service bulletin

No. 97-8

Revised June 1999. Information underlined is new.

MerCarb 2 bbl Carburetor

MerCarb Float Setting

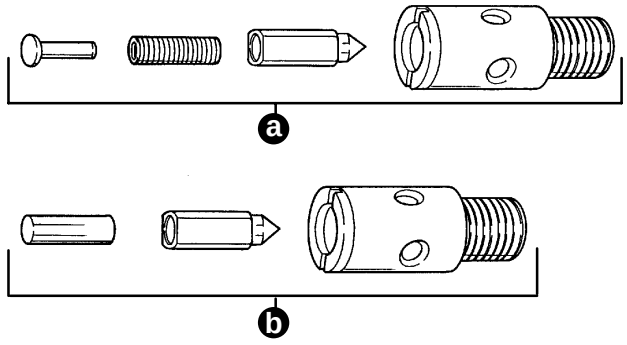
This is the float setting for all MerCarbs.

Needle/Seat	Float Level	Float Drop
Two Piece Solid:	3/8 in. (10 mm)	1-3/32 in. (27 mm)
Spring-Loaded (1):	9/16 in. (14 mm)	1-3/32 in. (27 mm)
(1) MCM, MIE 5.0L, 5.7L S/N 0L000001 and Above:		
	11/32 in. (9 mm)	15/16 in. (24 mm)

Electric Choke Operation, V8 Engines S/N 0F601000-0L000000

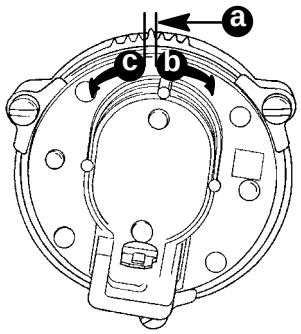
On these engines, a PUR/YEL wire connects the electric choke to a terminal on the alternator. The terminal on the alternator will not put out enough voltage to open the choke until the engine exceeds 800 RPM. If an engine is started and left to idle below 800 RPM, the choke may not open. This can cause a rich running condition. Whenever troubleshooting a choke opening problem on one of these engines, make sure that the engine RPM exceeds 800 when first starting.

Tell your customers to exceed 800 RPM for a short time after starting their engine. This will allow the alternator to start charging.

MCM 5.0L Running Rich at Idle or Just Above Idle, S/N 0F118346 and Below

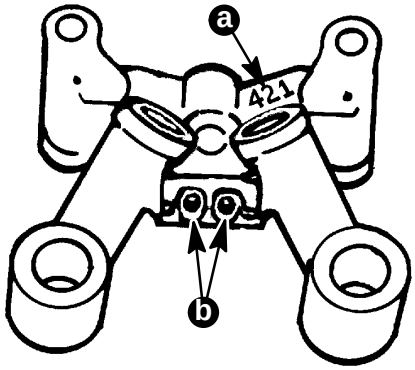
If you have a 5.0L engine below the serial number listed, and it has this problem, change the venturi cluster. Engines above the serial number listed used a carburetor that had the new venturi cluster. The idle circuit in this new cluster is leaner than the previous cluster.

NOTE: *This new cluster may give a lean pop on rapid acceleration with no load on the prop. Retest the boat in the water with the correct pitch propeller before trying to correct a problem that really is not there.*

3302-808706 Venturi Cluster.

72779

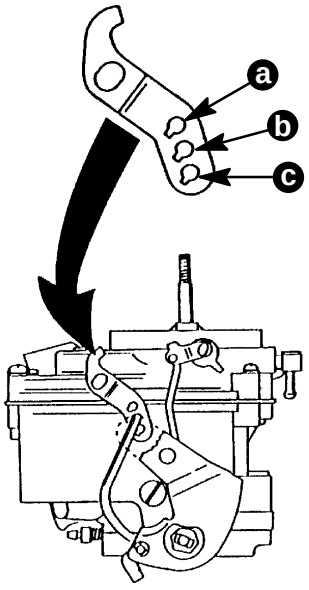
The venturi clusters are matched to the carburetor. Sometimes the replacement clusters get packaged wrong. Clusters have an identifying number on them. Refer to the service manual for the engine that you are working on for the correct cluster number.

a - Identification Number
b - Accelerator Pump Discharge Holes
